# Nomad

## ALERT SERVICE BULLETIN

### WINGS – STRUT – UPPER END FITTING (PN 1/N–20–643) – INSPECTION, REPLACEMENT AND BOLT REPLACEMENT (MOD N654A AND N654B)

The compliance requirements are amended by revising the initial inspection periods and including incorporation of Mod N654A and N654B using the line reamer shown in Figure 1.

**Figure 1 Special Line Reamer — Strut Upper End Fitting**

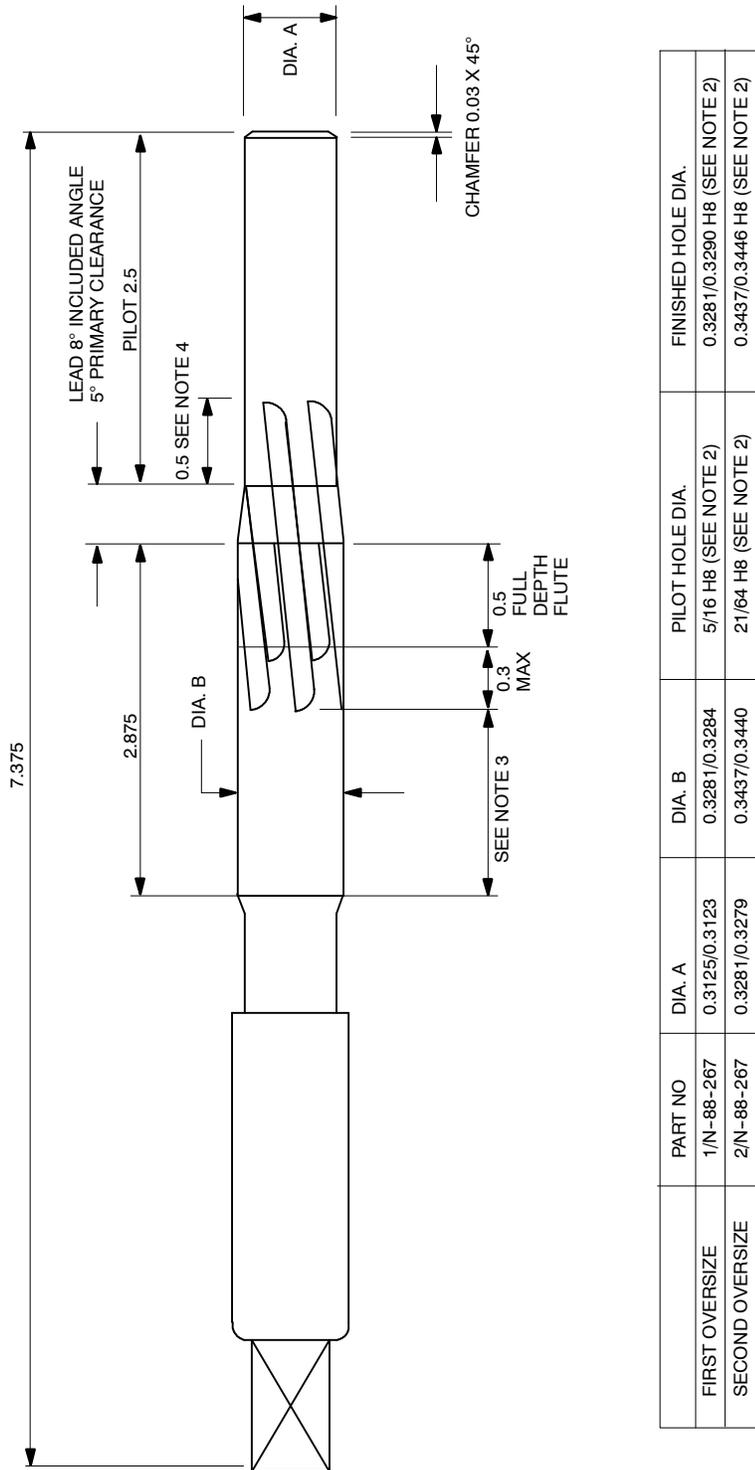
- (4) Carefully line ream the bolt holes, using a suitable lubricant, with special line reamer PN 1/N-88-267 for 1st oversize bolts and special line reamer PN 2/N-88-267 for 2nd oversize bolts (Ref Figure 1).

- (1) Special line reamers PN 1/N-88-267 (1st oversize) and PN 2/N-88-267 (2nd oversize) are available for purchase or lease from Boeing Aircraft Systems - ASTA, Nomad Support. Price available on application.
- (2) Alternatively, the special line reamers may be locally manufactured as per Figure 1.

- NOTES:
1. EXCEPT AS SHOWN, REAMER IS A HELICAL FLUTED (6 FLUTES) HAND REAMER MADE FROM HIGH SPEED STEEL - COMMERCIAL TO ANSI B 94.2-1964.
  2. FOLLOWING GRINDING, A TRIAL HOLE IN QQ-A-225/6 T 851 MATERIAL (PREVIOUSLY PILOT REAMED - REFER TABLE) IS TO BE REAMED USING SUITABLE LUBRICANT. FINISHED HOLE DIAMETER IS TO BE AS PER TABLE AND AT LEAST THREE FLUTES MUST BE SHARING THE CUTTING. REAMER TO BE RE-GROUND OR STONED UNTIL THESE CONDITIONS ARE MET.
  3. FLUTES NOT REQUIRED OVER THIS LENGTH. BACK TAPER NOT TO EXCEED LIMITS OF TOLERANCE ON DIA.
  4. NO CUTTING EDGES OVER THIS LENGTH.
